STAFF REPORT: REGULAR CALENDAR

APPLICATION NO.: 5-02-302

PROJECT LOCATION: 1806 East Balboa Boulevard & 1813 East Bay Avenue, City of Newport Beach, County of Orange

PROJECT DESCRIPTION: Demolish an existing single-family residence, garage & storage structure at 1806 East Balboa Boulevard and adjust lot lines. No further development is proposed at 1806 East Balboa Blvd. Demolish an existing single-family residence, garage and storage structure and construct a 9,488 square foot 2-story single-family home with a basement, attached 921 square foot garage and rear yard pool, with 785 cubic yards of grading & export and adjust lot lines, at 1813 East Bay Avenue.

L1.2 of	
DATE: 11/11/10 DRAWN BY: [Name] CHECKED BY: [Name] APPROVED BY: [Name]	
PROJECT: BATH RESIDENCE 1011 EAST BAY AVENUE HERMISTON BEACH, CA 92651	
LANDSCAPE LANDSCAPE PLAN	
SCALE: 1/8" = 1'-0" DATE: 11/11/10

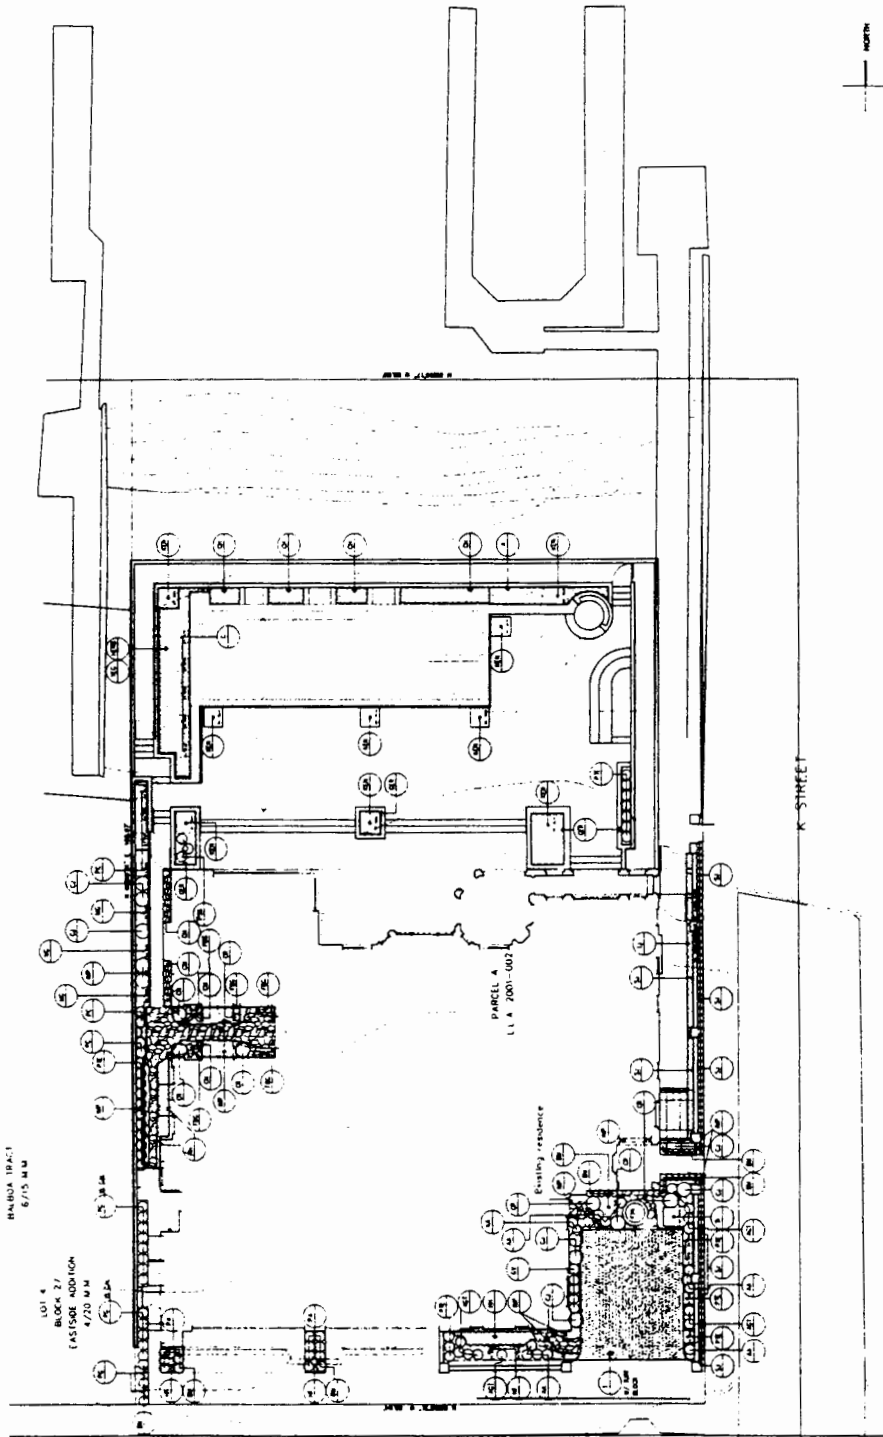
The project site is located immediately adjacent to a beach and Newport Bay. Development, if not properly regulated, could have adverse effects on the sustainability of any existing native vegetation. The applicants have submitted a Landscaping Plan (Exhibit #14), which contains elements that could affect the sustainability of any existing native vegetation. The submitted landscaping plan proposes use of the following vegetation: *Howea Forsteriana*, *Pittosporum Tenuifolium*, *Pittosporum Silver Sheen*, *Citrus*, *Podocarpus Gracillior* Low Branching, *Magnolia "Little Gem"* Low Branching, *Prunus Caroliana* Low Branching, *Cycas Revoluta*, *Hymenosporum Flavum*, *Azalea "Alaska"*, *Azalea "George L. Taber"*, *Buxus "Green Beauty"*, *Camellia Japonica "Nuccio's Gem"*, *Pittosporum Tobira "Variegata"*, *Roses "Iceberg"*, *Cuphea Hyssopifolia*, *Fuschia "Bonsted Gartenmeister"*, *Assorted Ferns*, *Clivia Miniata*, *Gardenia Jasminoides*, *Gardenia Veitchii*, *Annual Flowers*, *Pandorea Alba*, *Pandorea Rosea*, *Parthenocissus*

The placement of vegetation that is considered to be invasive which could supplant native vegetation should not be allowed. Invasive plants have the potential to overcome native plants and spread quickly. Furthermore, any plants in the landscaping plan should be drought tolerant to minimize the use of water. Consequently, Staff reviewed the proposed landscaping to determine if it contained any native plants that were common to coastal Orange County or non-native invasive vegetation or plants that were not drought tolerant by researching the *Ocean Trails-Restricted Plant List* dated October 6, 1997, *Recommended List of Native Plants for Landscaping in the Santa Monica Mountains* dated January 22, 1992, the *Sunset Western Garden Book* dated 1988 and also the *CalFlora* database. CalFlora is an independent non-profit organization, which maintains a comprehensive database of plant distribution information for California. Staff reviewed the submitted Landscape Plan and determined that the plan did not contain any invasive plants. However, the Landscape Plan did contain plants that were determined to be non-drought tolerant or that could potentially be non-drought tolerant because the watering needs for these plants could not be determined.

Fifteen of the thirty-two plants required moisture or regularly watering, while eleven were determined to be drought tolerant. The watering needed for six of the plants could not be found and also since one of the listed plants was only listed as "*Annual Flowers*," the watering requirement for these plants could not be found. The fifteen plants that need watering are: *Howea Foresterana*, *Podocarpus Gracillior Low Branching*, *Magnolia "Little Gem" Low Branching*, *Cycas Revoluta*, *Hymenosporum Flavum*, *Azalea "Alaska"*, *Azalea "George L. Taber"*, *Roses "Iceberg"*, *Cuphea Hyssopifolia*, *Fuschia "Bonsted Gartenmeister"*, *Gardenia Veitchii*, *Parthenocissus Tricuspidata*, *Geranium "Balcom Mix"*, *Trachelospermum Jasminoides*, and *Impatiens*. Since these plants are not drought tolerant, they should be removed from the landscaping plan. The six plants in which the watering need could not be found are: *Citrus*, *Clivia Miniata*, *Annual Flowers*, *Pandorea Alba*, *Pandorea Rosea*, and *Solanum Jasminoides*. Since the watering needs of these plants could not be determined, they should either be removed from the landscaping plan or have information submitted by a licensed landscape architect that these plants are drought tolerant.

- A. **PRIOR TO ISSUANCE OF THE COASTAL DEVELOPMENT PERMIT**, the applicants shall submit a revised landscaping plan to the Executive Director for review and approval. The revised landscaping plans shall only consist of native plants common to coastal Orange County and/or non-native drought tolerant plants which are non-invasive.
- B. The permittees shall undertake development in accordance with the approved plan. Any proposed changes to the approved final plan shall be reported to the Executive Director. No changes to the approved final plans shall occur without a Commission amendment to this coastal development permit unless the Executive Director determines that no amendment is required.

To minimize any effect on any native vegetation in the area, either native or non-native drought tolerant vegetation, which would not supplant native species, should be used. Therefore, the Commission imposes **Special Condition No. 8**, which requires the applicants to submit a revised Landscaping Plan, which consists of native plants common to coastal Orange County and/or non-native drought tolerant plants, which are non-invasive. Therefore, the Commission finds that, as conditioned, the proposed development would be consistent with Section 30240 and 30251 of the Coastal Act.
